N° 2014-097-A

Implementation of halogen-free mold compound and copper wire bonding for products assembled in lead-free package PG-SC59

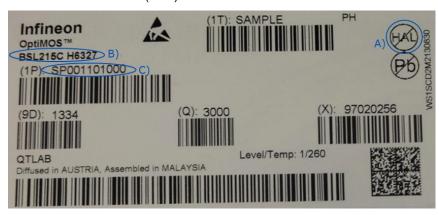
DESCRIPTION OF CHANGE:	OLD	<u>NEW</u>
■ Mold Compound	Mold compound containing Halogen	Halogen-free mold compound
■ Wire Bonding Material	Au Wire	Cu Wire
■ Product Barcode Label	Pb free logo	Pb free and halogen-free logo

- A) Halogen-free logo printed on barcode label
- B) "L" in sales code will be substituted by "H" to indicate the halogen free¹⁾ mold compound
- C) New customer ordering code
